HISTORIC PRESERVATION BOARD STAFF REPORT

202 N. Swinton Avenue

Meeting	File No.	Application Type
October 16, 2024	2024-192	Certificate of Appropriateness, Level 1 Site Plan Modification, Demolition, and Variance

A1 ARCHITECTURAL SITE PLAN

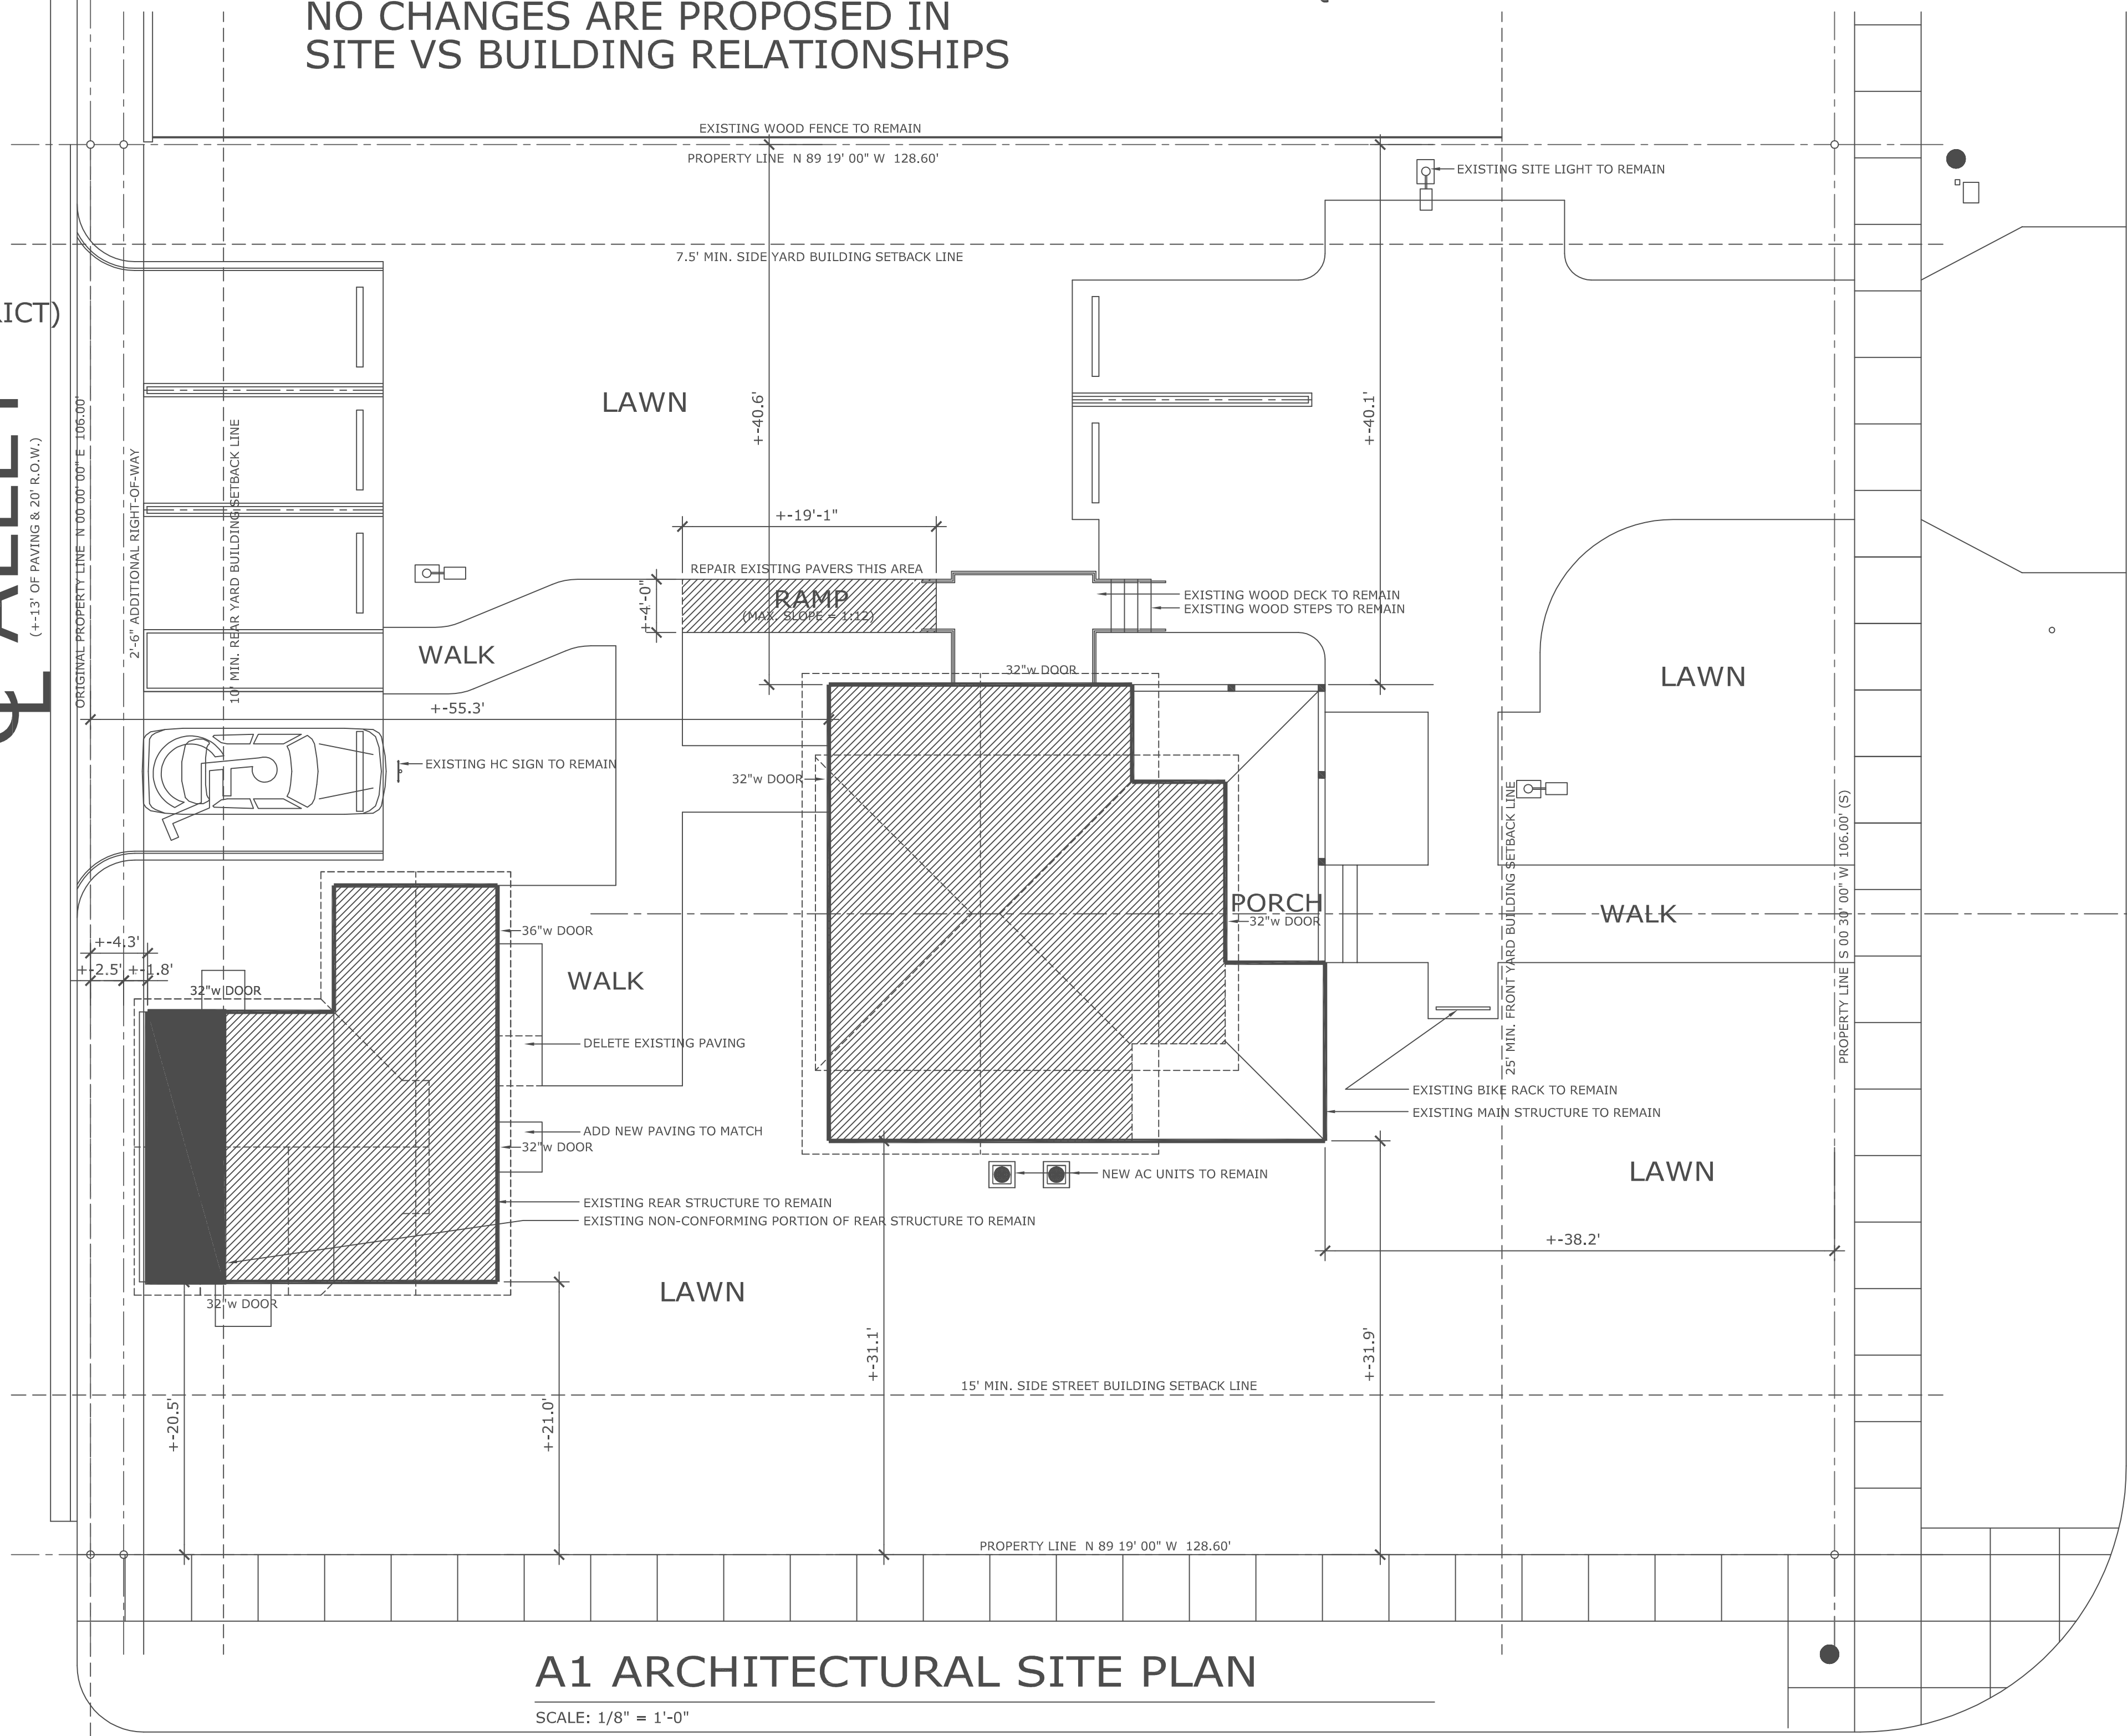
The existing historic accessory structure was situated 1.8' from the rear property line, where a 10' rear setback is required.

Pursuant to Section 4.3.4(K), Development Standards Matrix, the required rear setback within the OSSHAD District is 10'. The requested variance is to allow reconstruction of the historic accessory structure in its original configuration, with a 1.8' rear setback where 10' is required.

A12 FINAL REVISIONS REAR (WEST) ELEVATION: REAR STRUCTURE

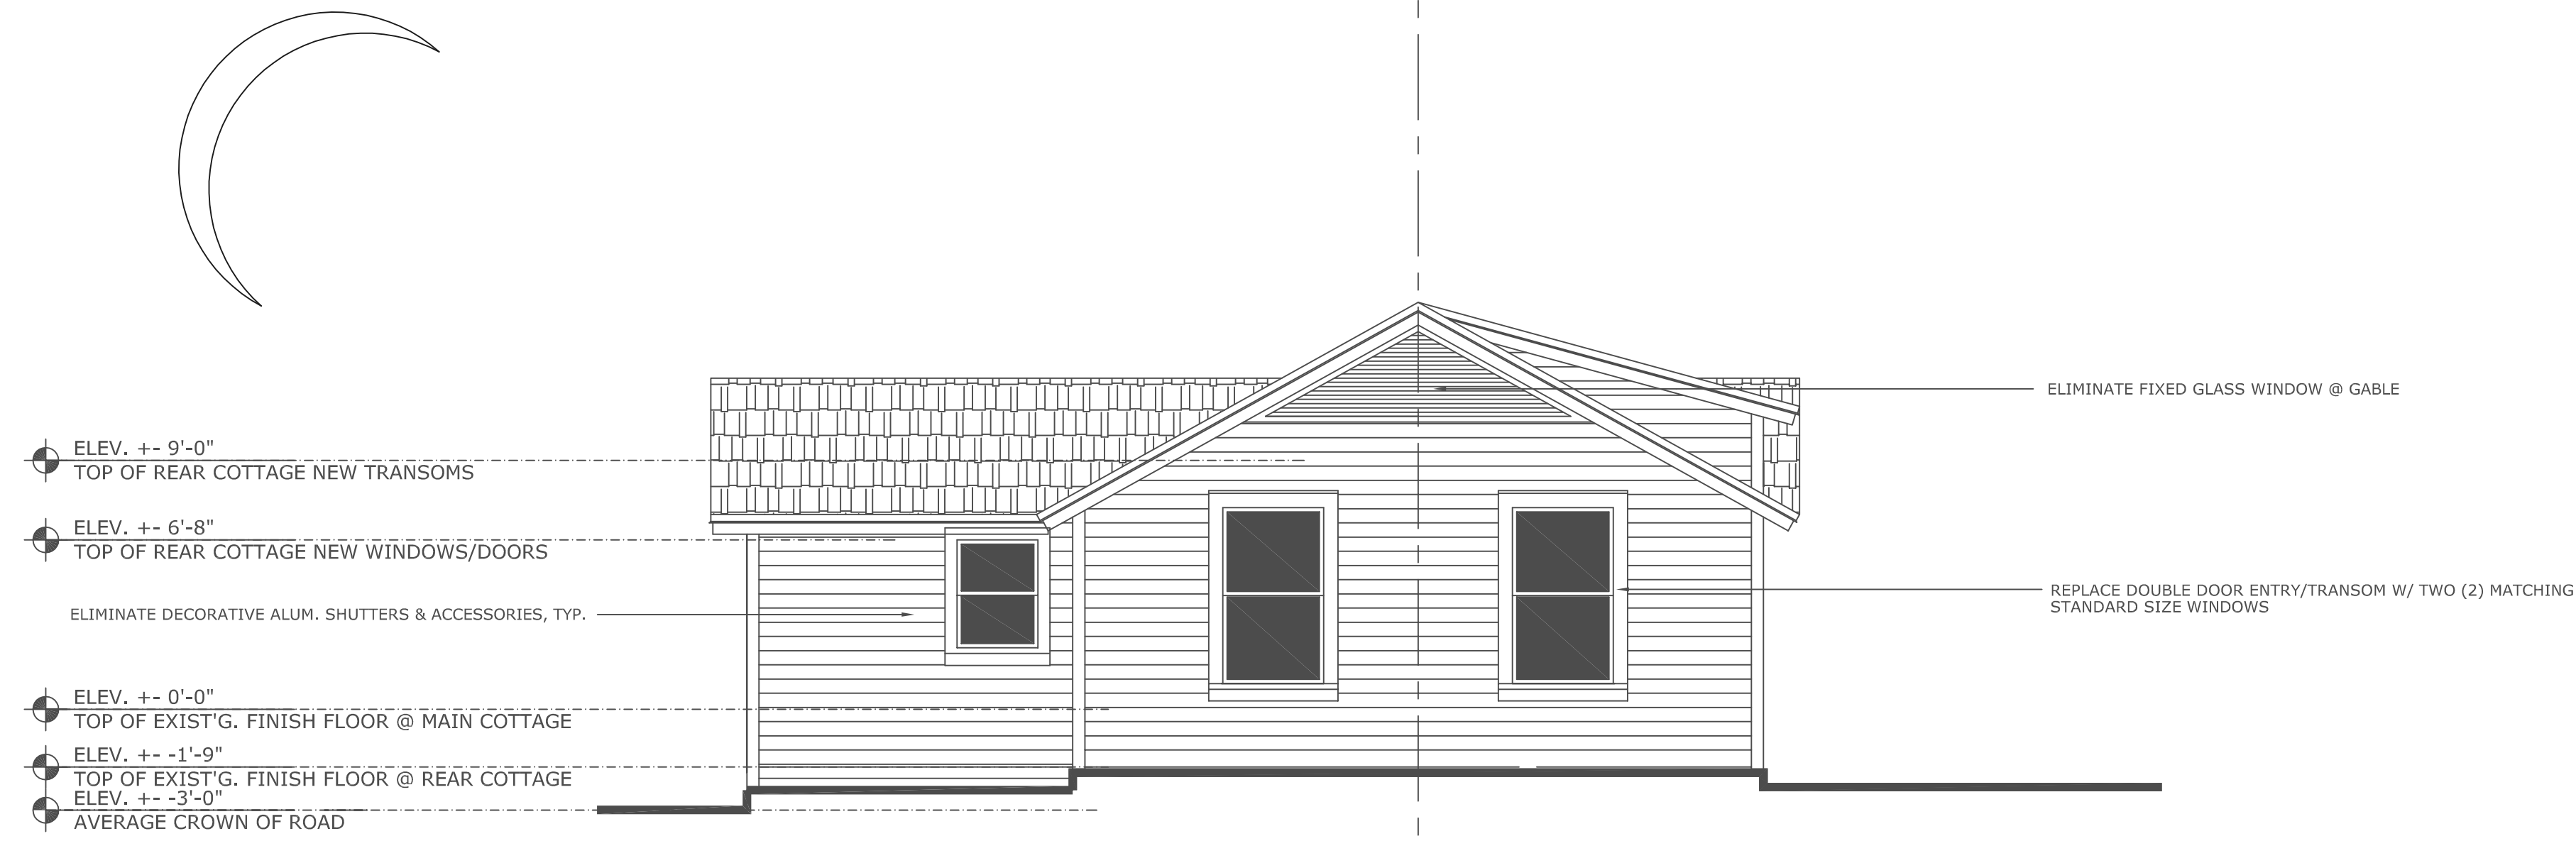
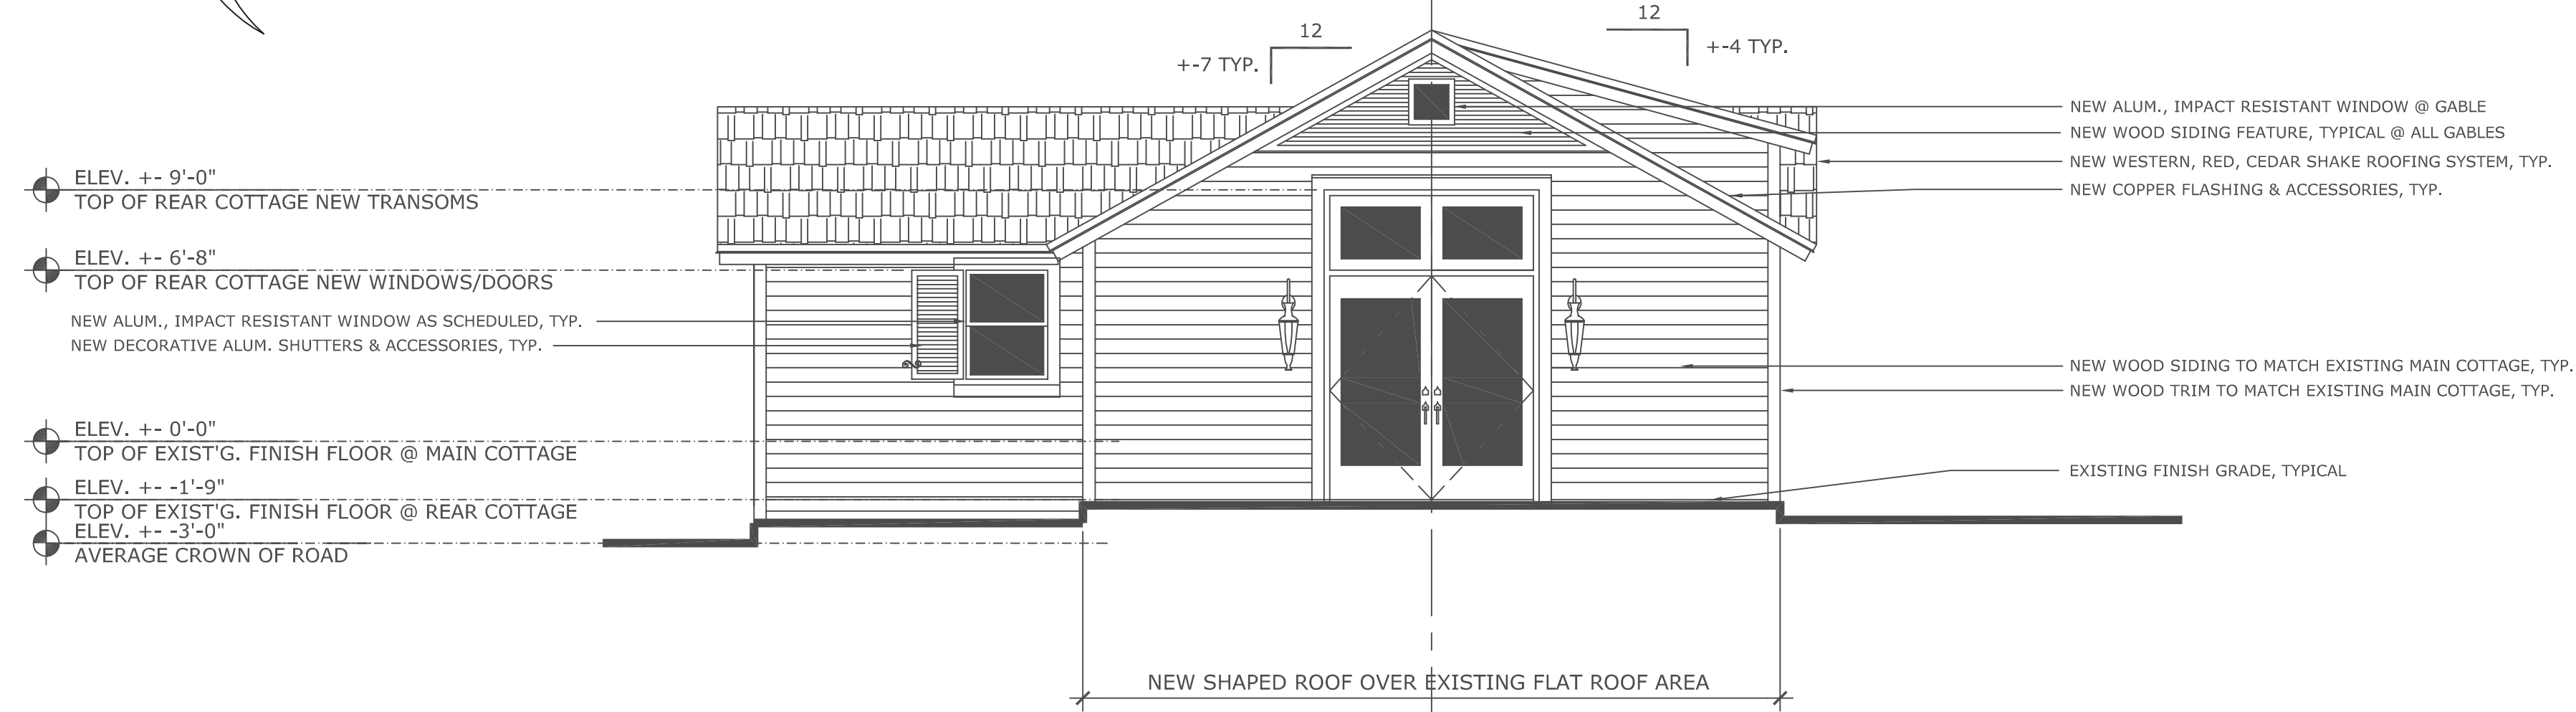
1. South Elevation: Elimination of the approved transom window above the entry door and elimination of the fixed window.
2. East Elevation: Installation of a single-entry door where a double French door was approved and elimination of the fixed glass window.
3. West Elevation: Installation of two single hung windows where a set of double French doors were approved and elimination of the approved fixed window on the gable.

4. South Elevation: Elimination of the approved transom window above the entry door and elimination of the fixed window.
5. East Elevation: Installation of a single-entry door where a double French door was approved and elimination of the fixed glass window.
6. West Elevation: Installation of two single hung windows where a set of double French doors were approved and elimination of the approved fixed window on the gable.
